**Operator: HIGHPOINT OPERATING CORPORATION**

**Location Name: Anschutz-Williams 5-61-27 SWSW**

**Loc ID: 452726**

**Inspection: 696305384**

**Exhibit A**

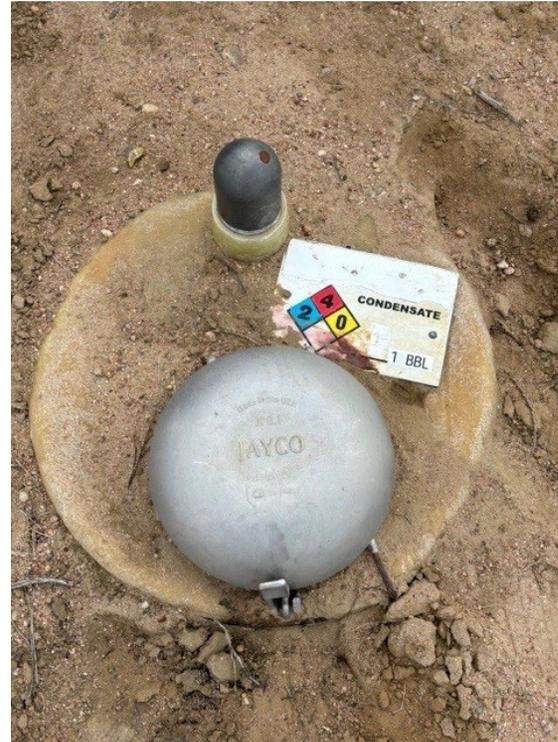
**CA:** Condensate Vault West of Separators is buried by Sand, Labels no longer visible. Condensate Vault at NW Corner of Tank Berm missing Capacity Label. Install sign to comply with Rule 605.h.

**CA Resolution:** Identified Condensate Vaults have been appropriately addressed by the Operator to ensure that the proper signage is up to date and visible to comply with Rule 605.h.
